Public Hearing
Virginia Graeme Baker Pool and Spa Safety Act
Unblockable Drain Guidance

Wednesday, November 4, 2009
9:00 a.m.

Re: "Unblockable Drain Guidance"

The Association of Pool & Spa Professionals (APSP) appreciates the opportunity to review the amendments to the Commission's Draft Technical Guidance Document on Unblockable Drains posted in the Federal Register, October 21, 2009.

Torso Specimen/Body Blocking Element Above

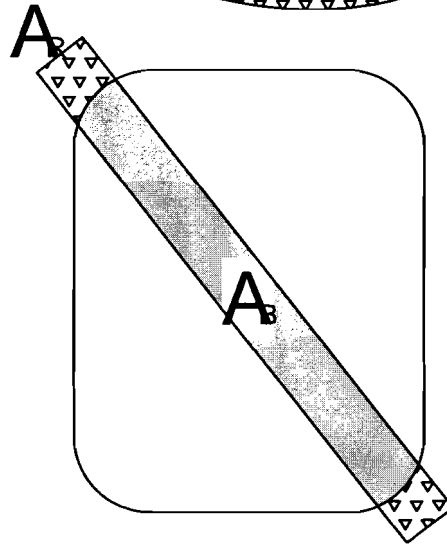
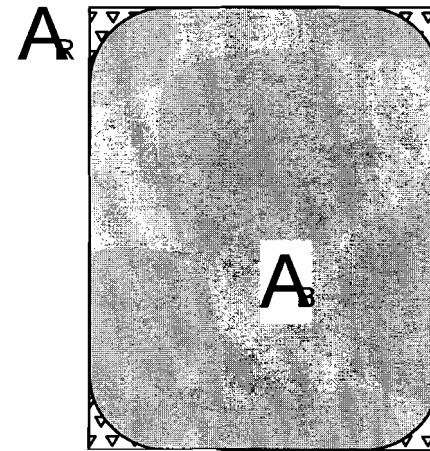
Discussion: A hypothetical 18 x 23 perforated area (29.2 inch diagonal) leaves a very small open area remaining when blocked by the 99 percentile man. The allowable flow is only 146 gpm, making such a product commercially impractical. It is less than half the rating of a much smaller Channel. If the more typical flow rating, corresponding to some local codes of 1.5 fps through the open area is used, the entrapping force exceeds three tons on the 99 percentile man, making it dangerous as well. A nominal 24 x 24 is better suited for this product category.

Top Center is specimen on arbitrary large grate

Right top is the specimen partially blocking a 24 x 24 cover/grate, showing the Area Blocked and the Area Remaining allowing flow

Near right shows a 3 x 31 channel diagonally. Note this position is chosen to be the most challenging, maximizing the Area Blocked and minimizing the Remaining Area.

At far right is the specimen blocking a rectangular grate with rectangular perforated area 18 x 23 allowing flow only through small area at corners producing a commercially useless flow rating

Channel conversion of 18 x 18

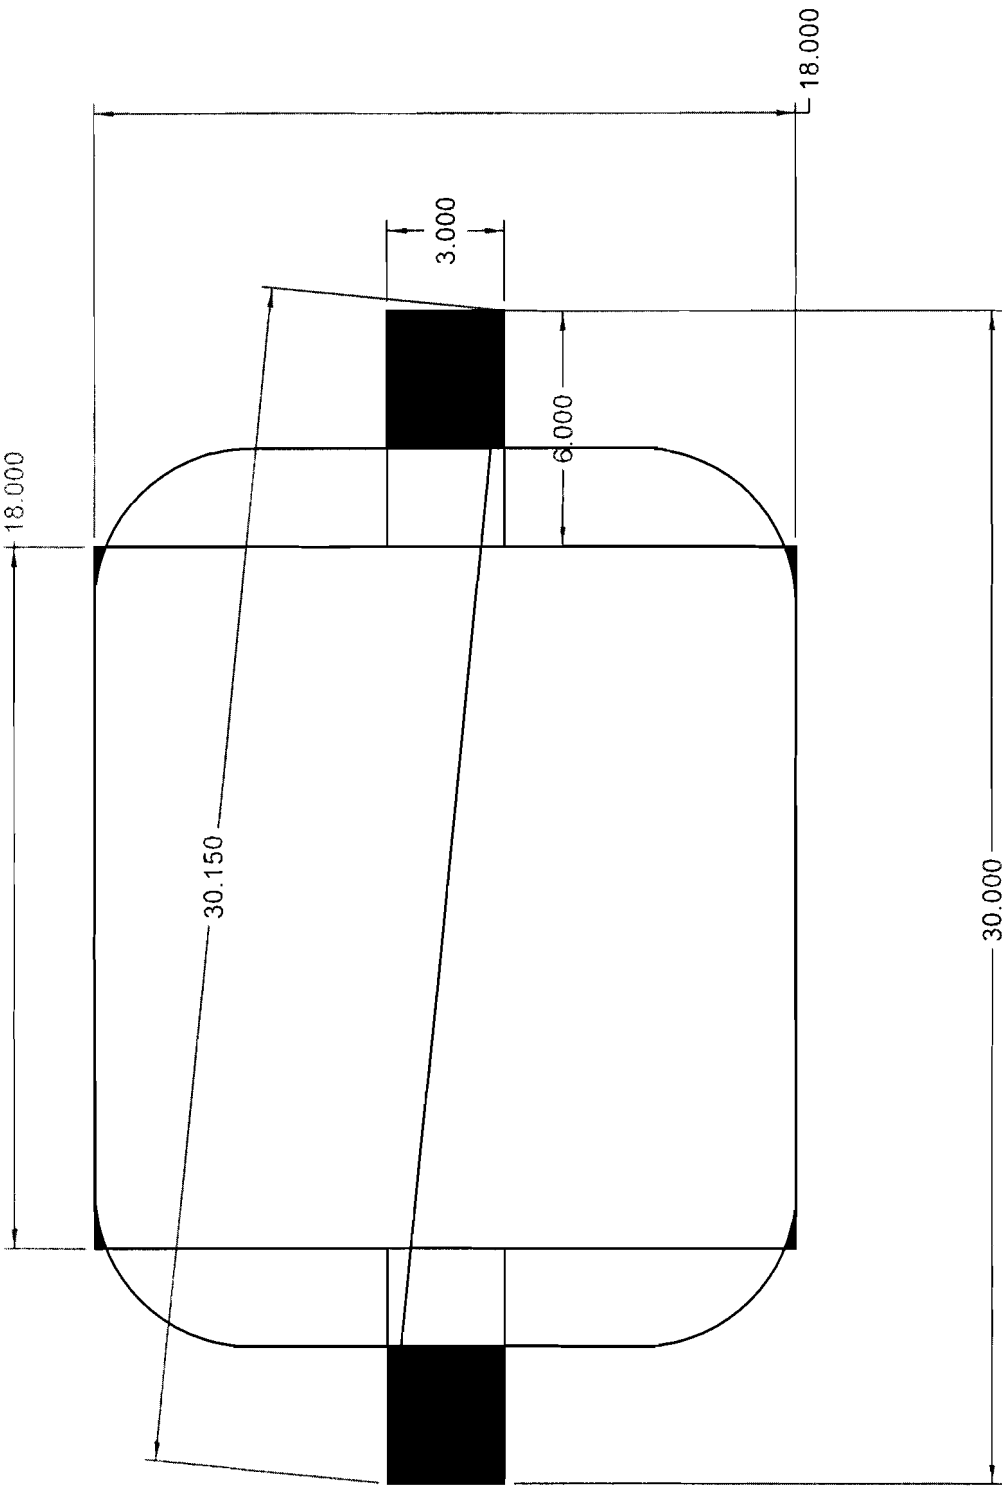
Now consider an existing cover with uniformly perforated area 18 x 18 inches with open area of 55%, with (2) 3 x 6 channels added to create diagonal greater than 30".

Suppose the outlet was mistakenly operated at this "expected" flow.

$$F_{\text{mistake}} = 1413 \text{ lbf}$$

This is dangerous, even for a strong man

The 2006 ICC Code had an 18 x 23 RECTANGLE

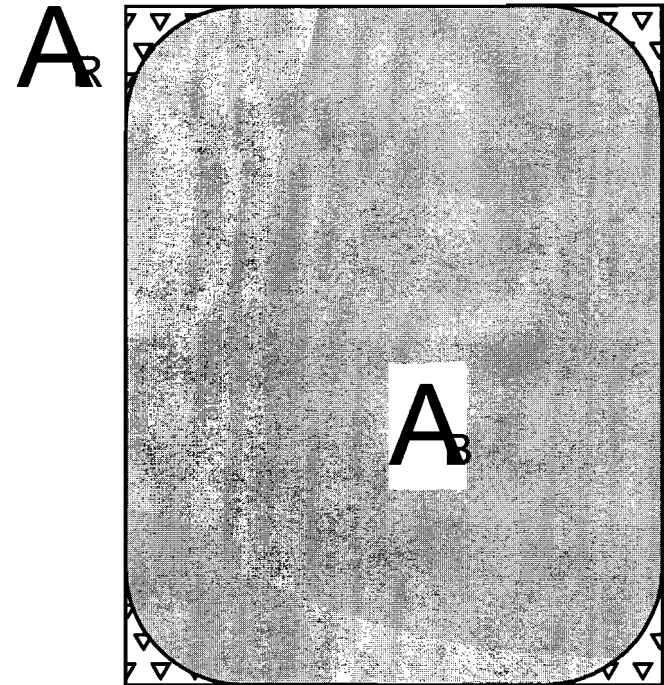
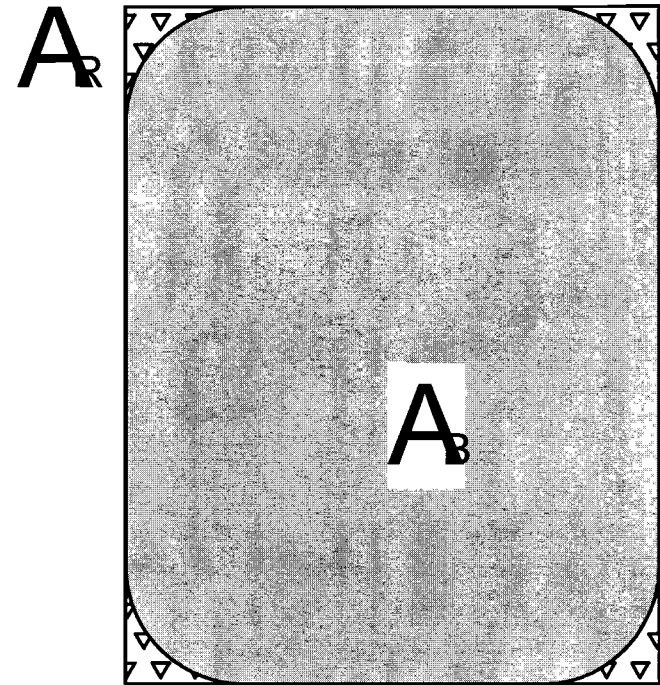
- Assumed Rounded corners for flow?
- Remaining grate area of 14 sq in
- Half is open area = 7 sq in
- Nominally, 1.5 fps thru open area of $18 \times 23 \times .50 = 207$ sq in
- Now forced through 7 sq in
- Velocity: $1.5 \times (207/7) = 44$. fps
- Velocity head
 $q = 44^2 / (2g) = 31$ ft wc = 13.25psi
- Loss coefficient from A112.19.8 = 2.1
- Drop thru grate = $2.1 \times 13.25 = 27.8$ psi
- Impossible - water would vaporize
 - (unless very deep)
- A very small flow rate would be OK
 - But why build such a big outlet?

- Assumed Rounded corners for flow?
- Remaining grate area of 14 sq in
- Half is open area = 7 sq in
- Nominally, 1.5 fps thru open area of $18 \times 23 \times .50 = 207$ sq in
- Now forced through 7 sq in
- Velocity: $1.5 \times (207/7) = 44$. fps
- Velocity head
 $q = 44^2 / (2g) = 31$ ft wc = 13.25psi
- Loss coefficient from A112.19.8 = 2.1
- Drop thru grate = $2.1 \times 13.25 = 27.8$ psi
- Impossible - water would vaporize
 - (unless very deep)
- A very small flow rate would be OK
 - But why build such a big outlet?

“Converting” 18x18” to 29” diagonal

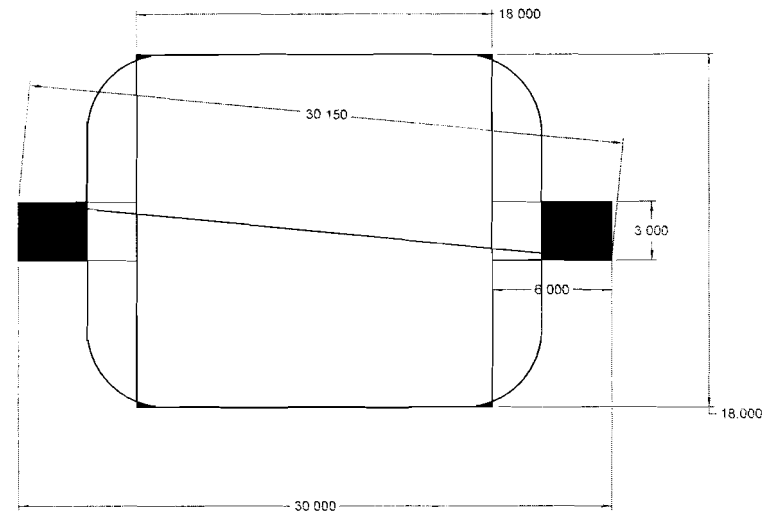
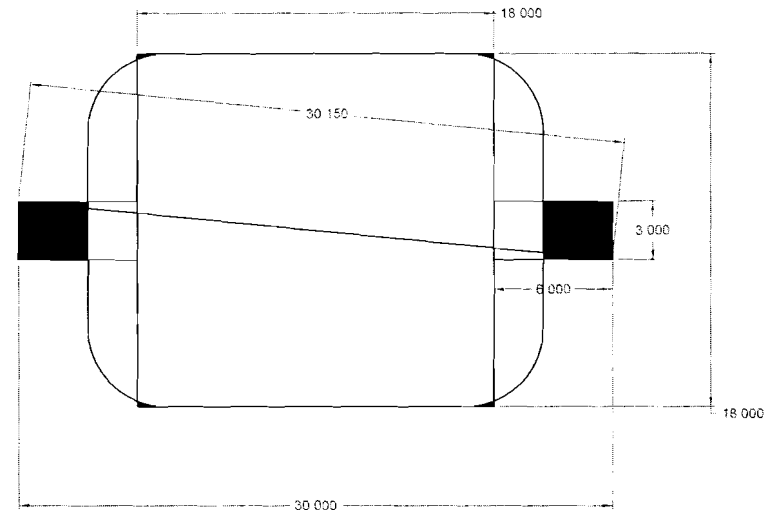
- Add stub channels to existing 18 x 18 with 55% opening
- Was 833gpm @ 1.5 fps
 - Although this was unsafe
- Now only 243gpm
- Operator expects at least same rating
- Holding force at old “expected” flow is 1413 pounds

- Add stub channels to existing 18 x 18 with 55% opening
- Was 833gpm @ 1.5 fps
 - Although this was blockable
- Now only 243gpm
- Operator expects at least same rating
- Holding force at old “expected” flow is 1413 pounds

An interesting Configuration

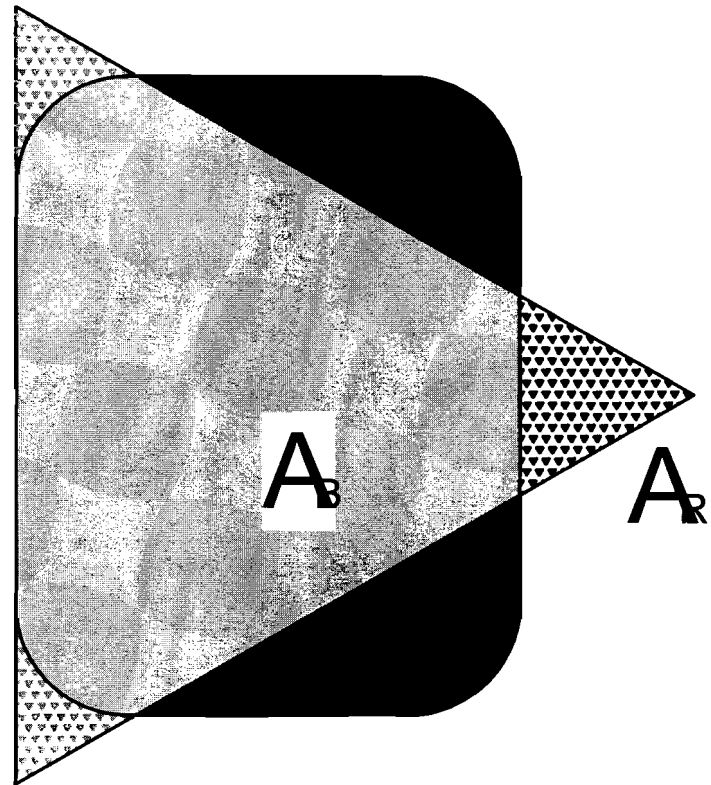
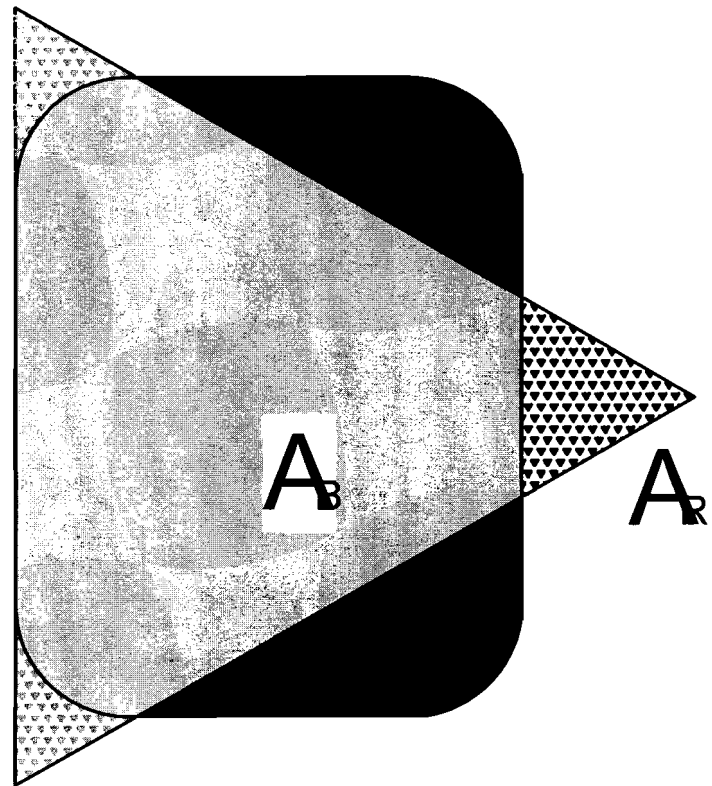
- An equilateral triangle of side 28" would be incorrectly excluded by a 29" diagonal rule.
- It would have a flow rating of 495 gpm

- An equilateral triangle of side 28"
- Would be incorrectly excluded by a 29" diagonal rule.
- It would have a high flow rating: 495 gpm

Top-Perforated Cover over smaller sump

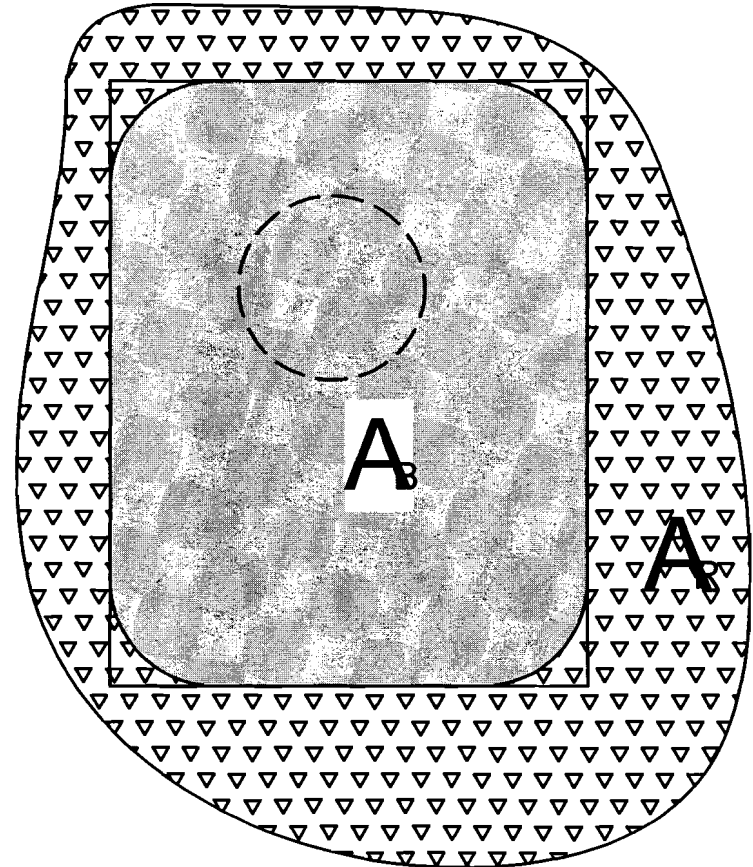
- Cover perforated on Top Surface Only
- Test is valid
- Calculation per A112.19.8
 - Not applicable
 - Extra resistance
 - “Remaining” holes close to floor
 - contrary to basis, which assumes direct flow to sump

Edge-Only Perforated Cover

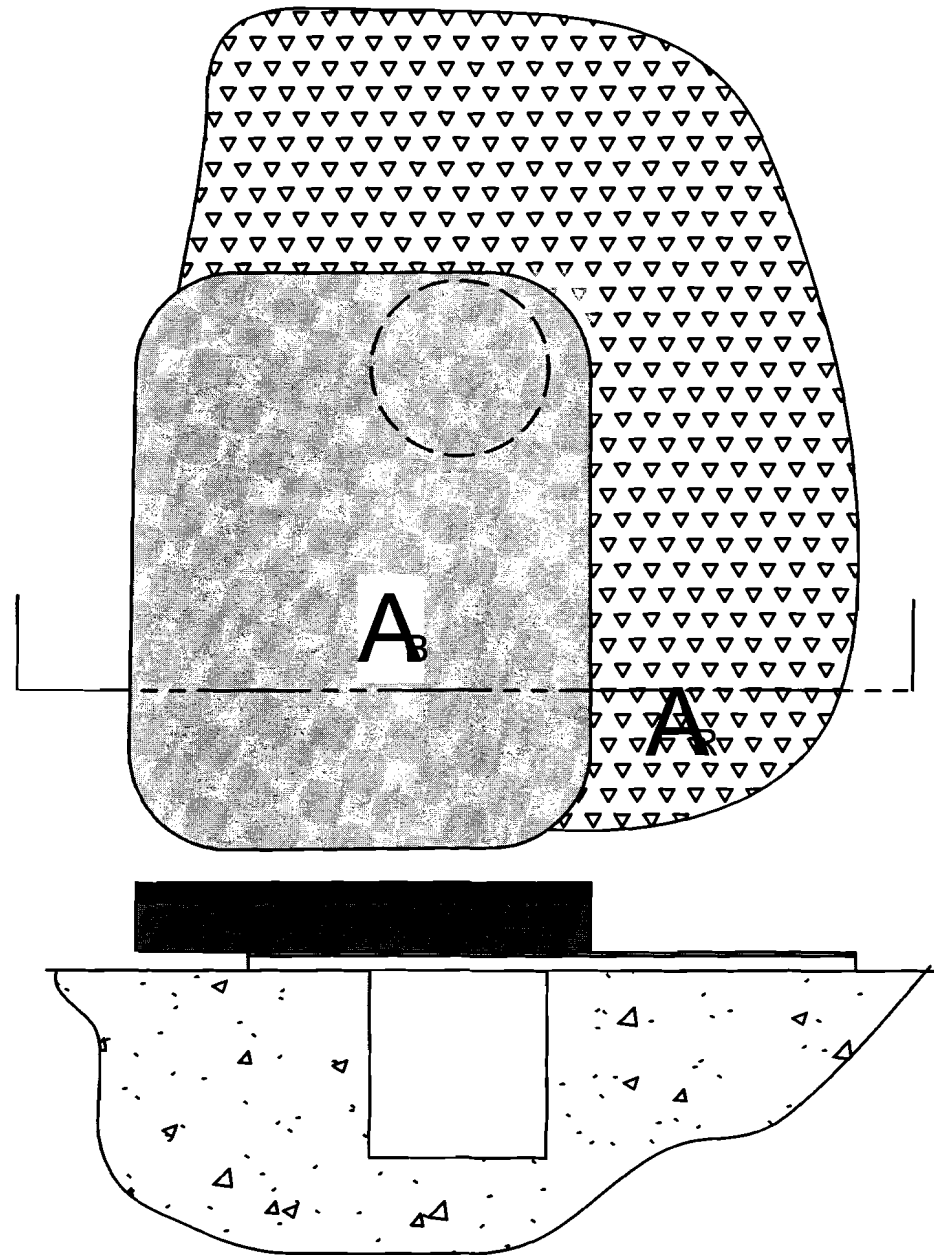
- Calculation not applicable
 - Plywood/Foam Element not in contact with holes
 - Different Effect:
Low pressure between element and floor due to
 - Fluid drag
 - Bernoulli's law
- Test not applicable
 - Element behavior

Edge-Only Perforated Cover

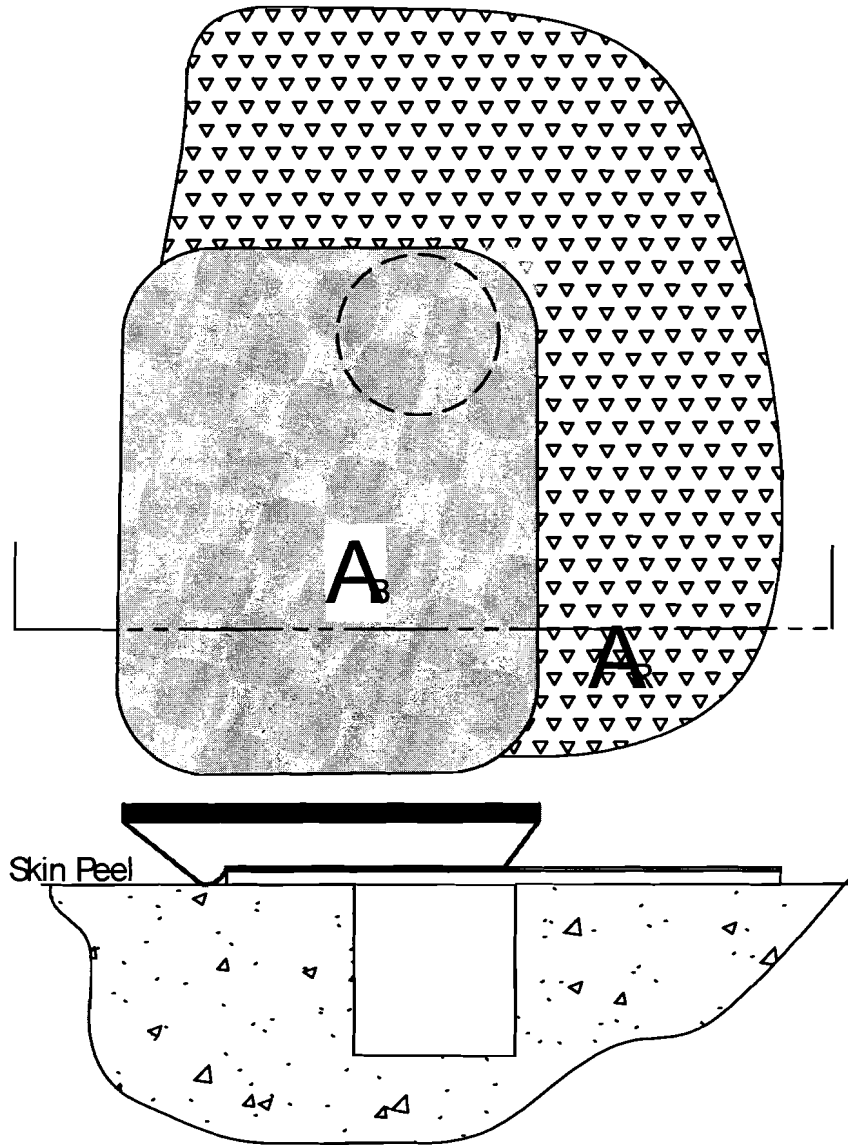
- Actual body/skin behaves differently
- Plywood = rib cage
- Skin separates from ribs
- Skin conforms to cover
- Skin peels away
